Re: University of Florida Training Reactor
Facility License R-56
Docket No. 50-83

The enclosed package contains Revision 2 pages for the UFTR Safety Analysis Report dated January, 1981 submitted as part of our relicensing effort.

DETAILED DESCRIPTION UFTR SAR REVISION 2

FINAL SAFETY ANALYSIS REPORT
UNIVERSITY OF FLORIDA TRAINING REACTOR
FACILITY LICENSE R-56; DOCKET NUMBER 50-83

Figure 1-8. NI CHANNEL 1: UFTR Nuclear Instrumentation Channel 1 Diagram (Log N, Safety #1 and Period Channels).

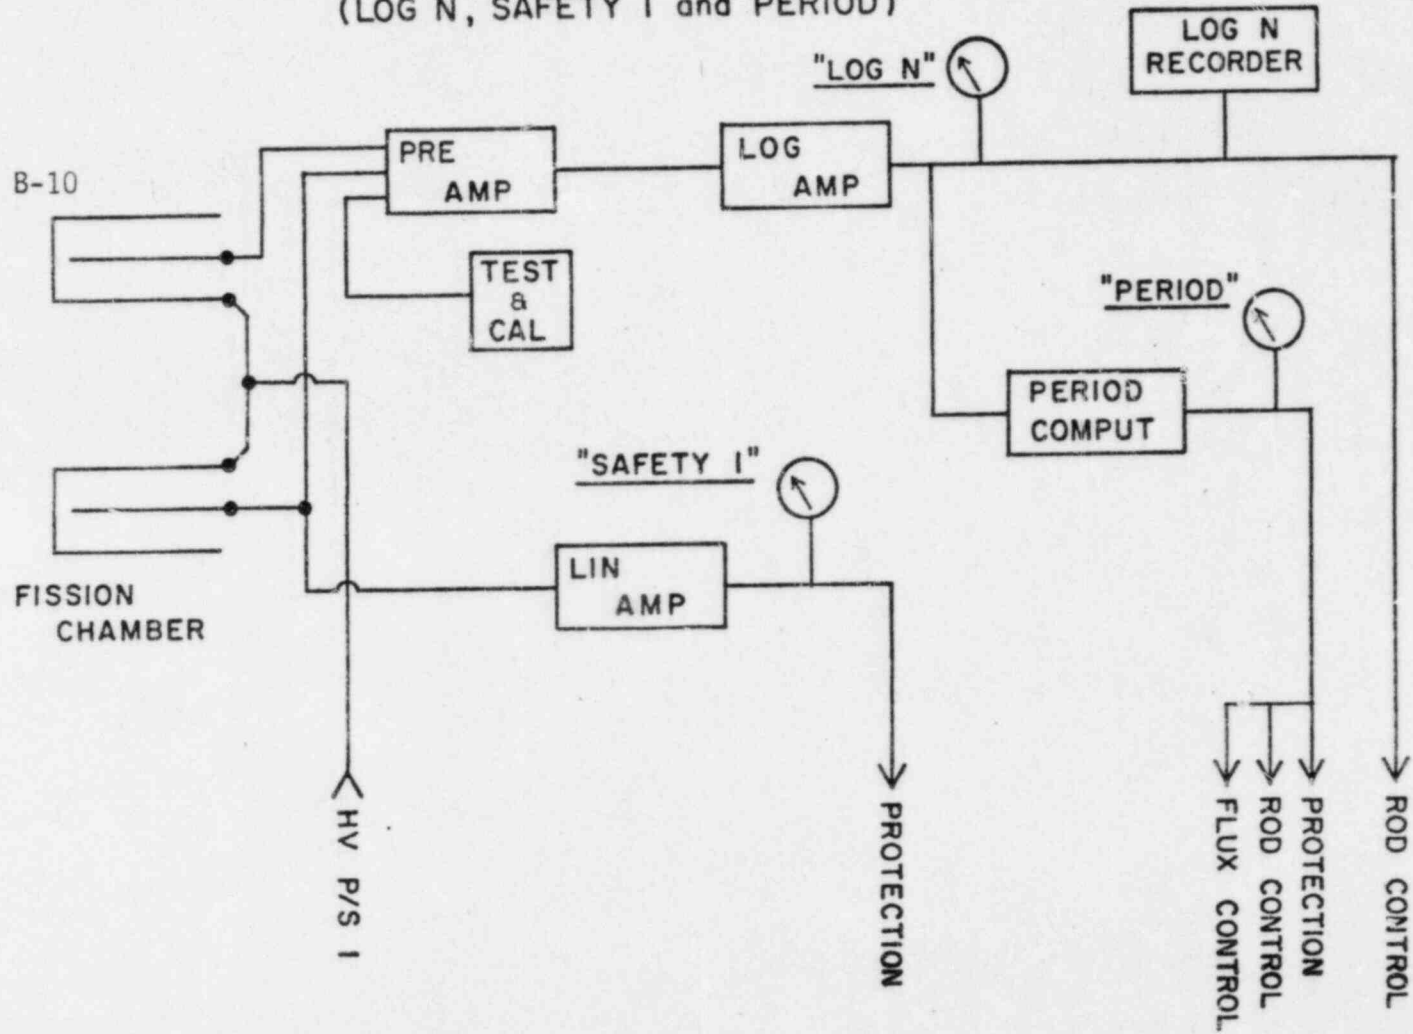
First, Figure 7-3 in Section 7.2 and Figure 1-8 were noted to indicate a BF_3 proportional chamber detector for the source range detector in Nuclear Instrumentation Channel 1. This detector is described as a B-10 proportional detector in the text of Section 7.2, Paragraph 7.2.2.1.1; in addition, the B-10 detector, not a BF_3 detector was in place when the SAR was submitted. To correct the improper indication of the source range detector from a BF_3 detector to a B-10 detector, a corrected Figure 1-8 is attached. The same change is made on Figure 7-3.
